# HISTORIC AND DESIGN REVIEW COMMISSION

**HDRC CASE NO:** 2024-379  
**ADDRESS:** 114 DEWBERRY ST  
**LEGAL DESCRIPTION:** NCB 6461 (MISTLETOE ADDITION SUBDIVISION), BLOCK 1 LOT 57  
**ZONING:** R-4, H  
**CITY COUNCIL DIST.:** 1  
**DISTRICT:** River Road Historic District  
**APPLICANT:** Joseph Keresztury/True Stone Custom Homes, LLC  
**OWNER:** Stephanie Pina/PINA DANIEL & STEPHANIE  
**TYPE OF WORK:** New Construction  
**APPLICATION RECEIVED:** January 15, 2025  
**60-DAY REVIEW:** March 16, 2025  
**CASE MANAGER:** Caitlin Brown-Clancy

The applicant is requesting a Certificate of Appropriateness to construct a new 2-story, single-family residence totaling approximately a 2,400 sf building footprint with an attached porte cochere.

ELEVATIONS

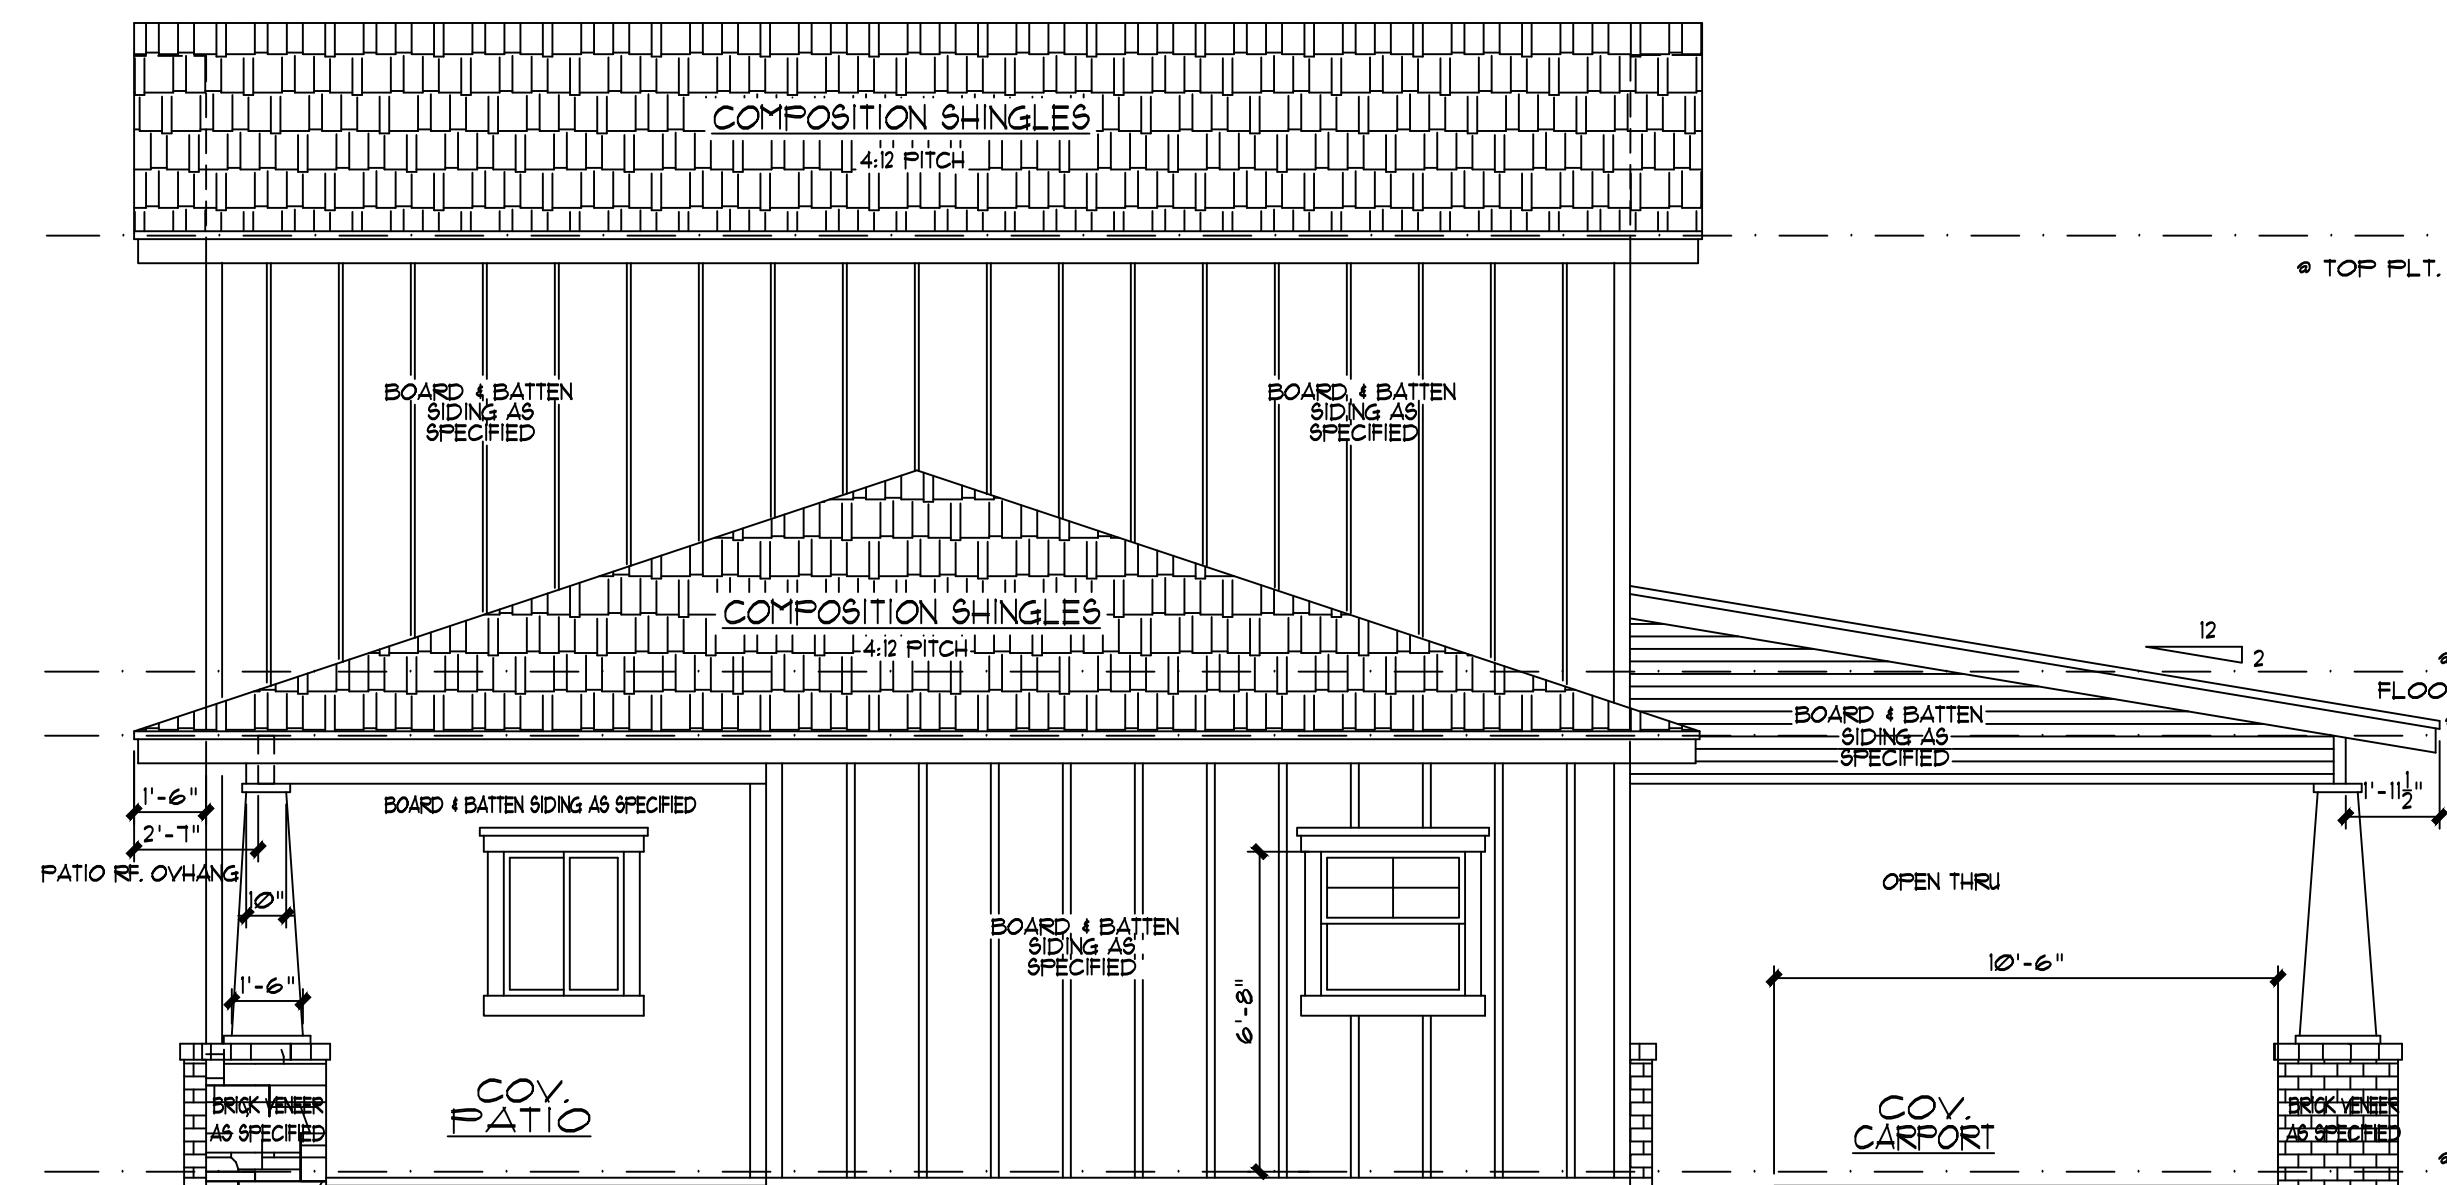
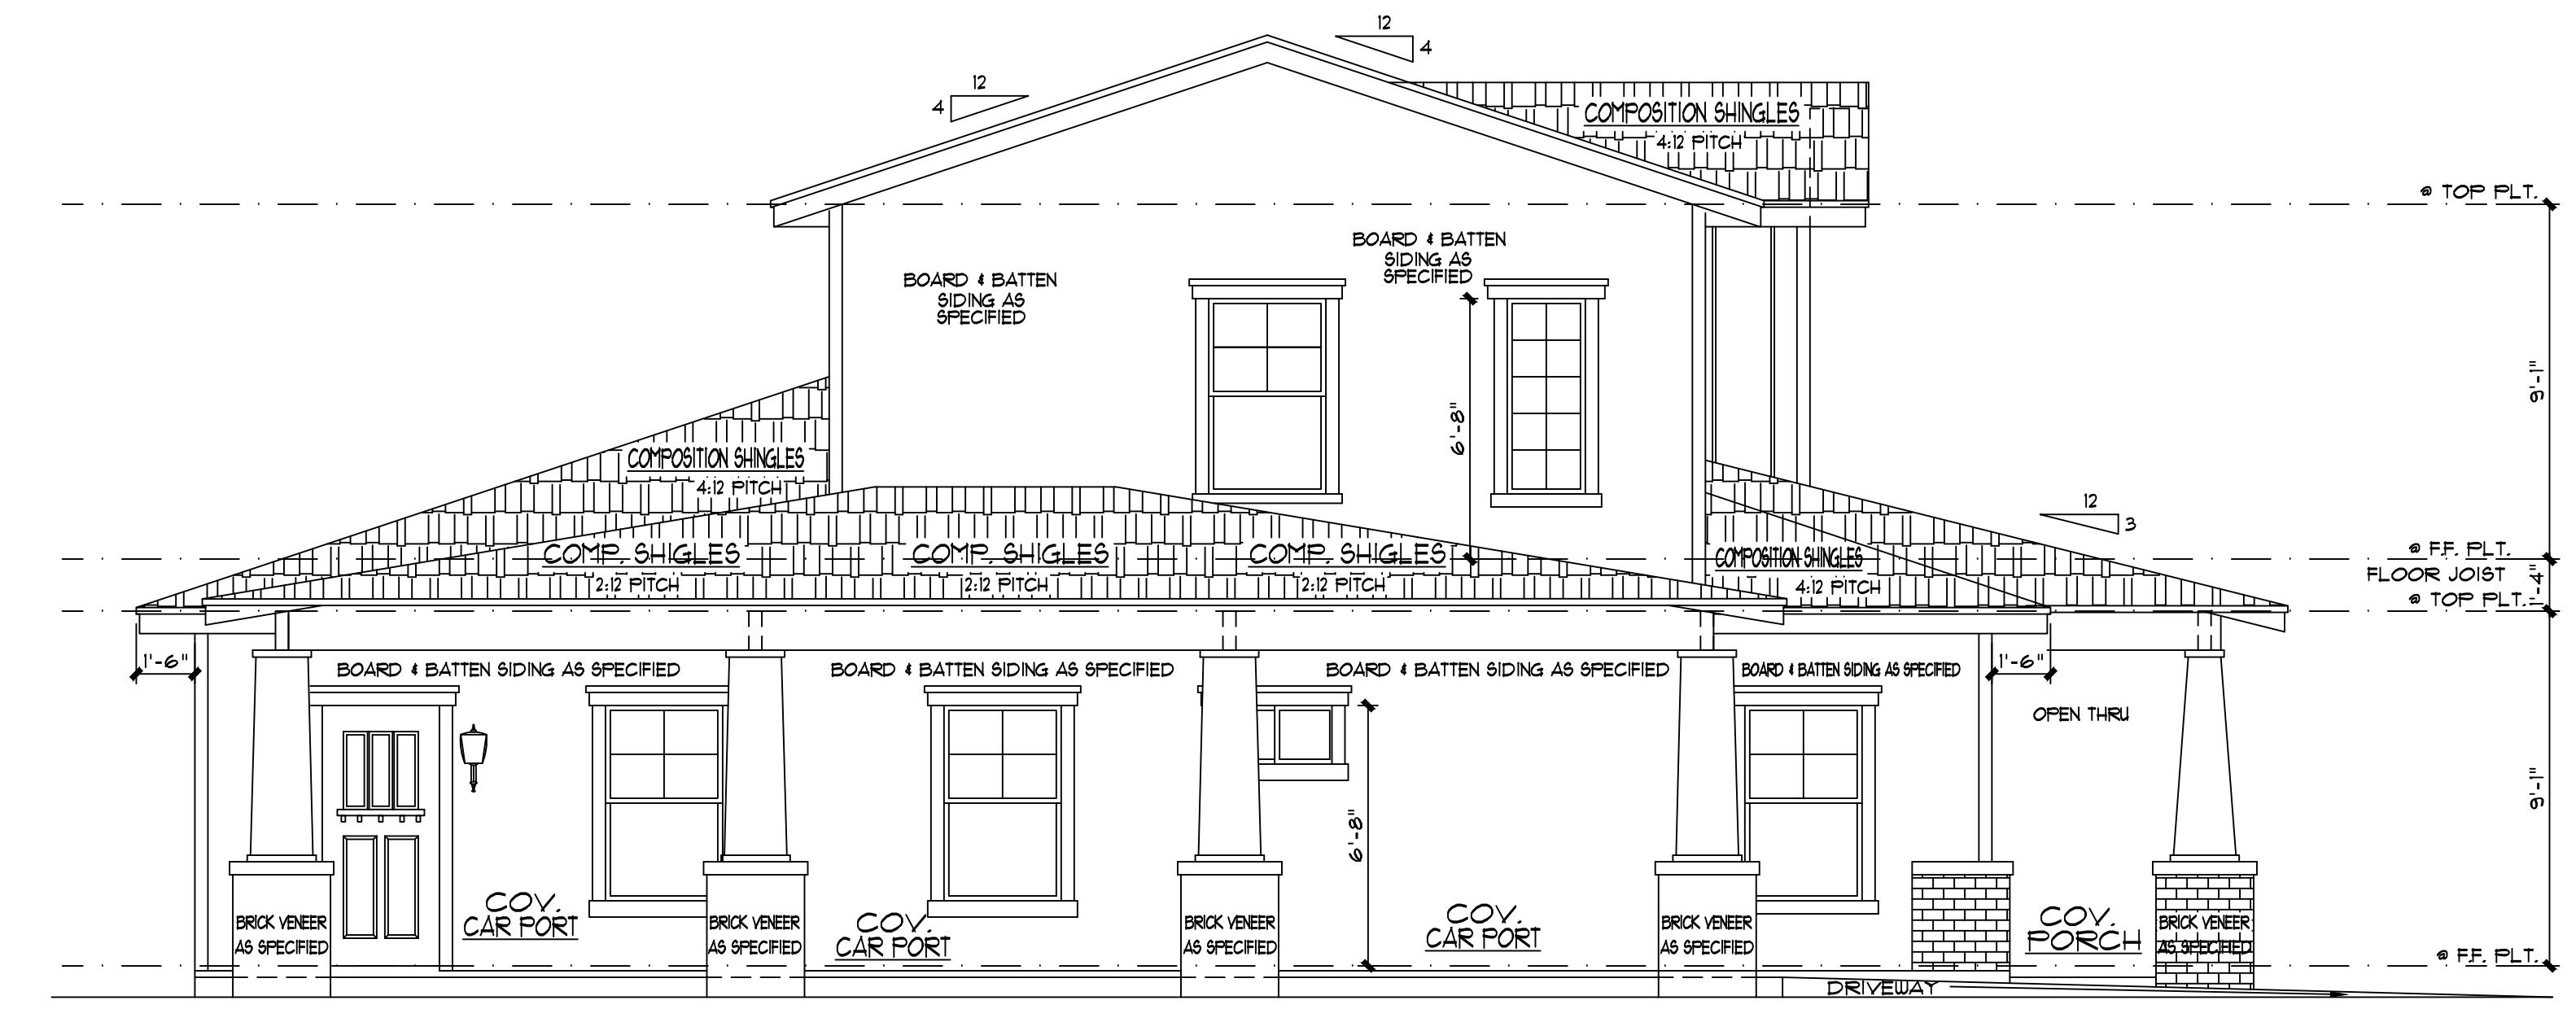
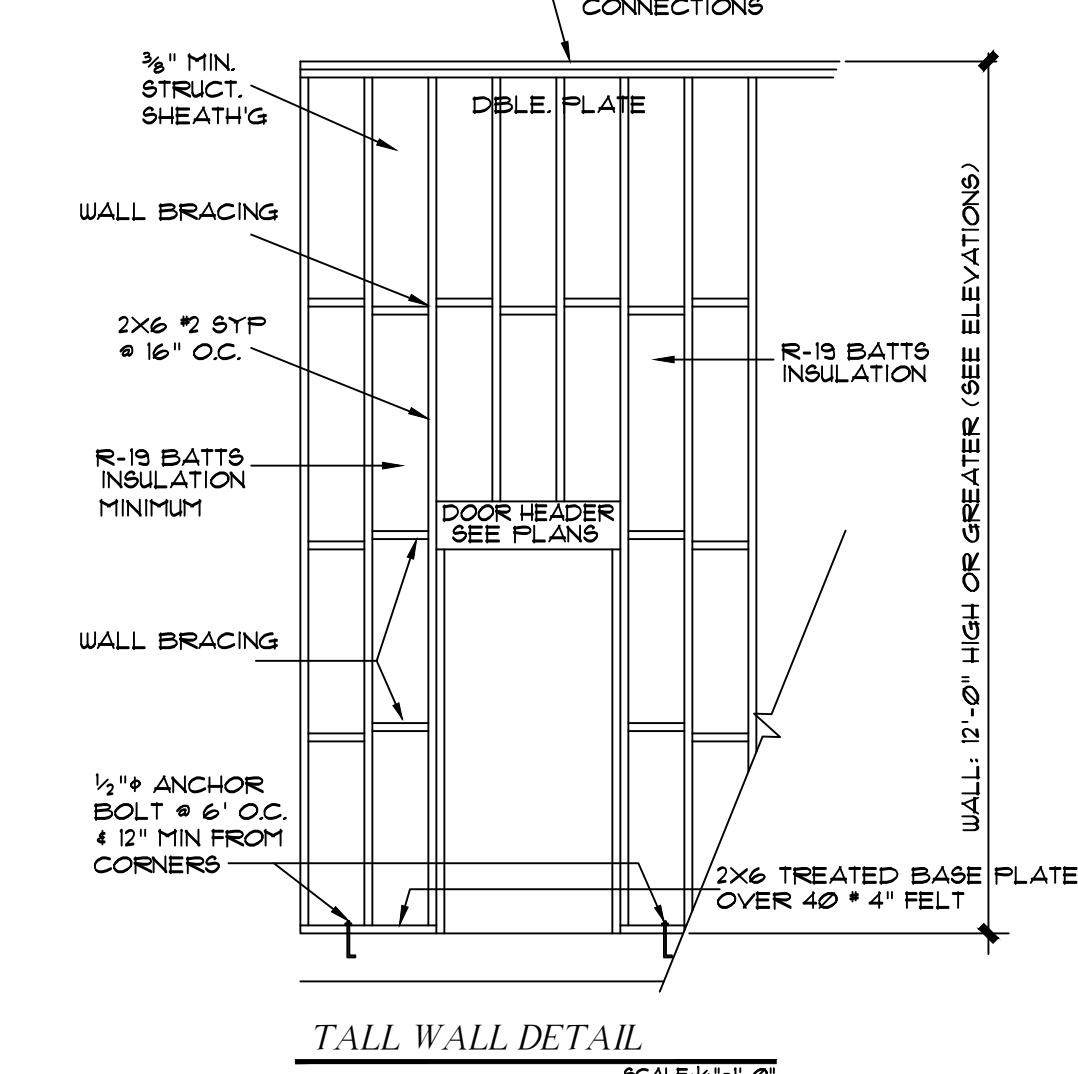
Jeffrey Fetzer – Suggested revising window placement on right and left elevations to be centered on gable vent. Consider window type/placement of 10 light window on left elevation to read more subordinate. Reduce ceiling heights/incorporate vaulted ceiling to bring overall height of structure down even further as second story is “top-heavy”. Incorporate 6” mullions on all “ganged” windows. Utilize taller window proportion for all sashed windows.

Jimmy Cervantes - Add additional fenestration to gable on right elevation

Roland Mazuca – Center windows on side gables and utilize taller window proportion for all sashed windows.

- ***Reduce height of second story gable***
- ***Refine window placement on second story gables***
- ***Utilize taller window proportion on all sashed windows***
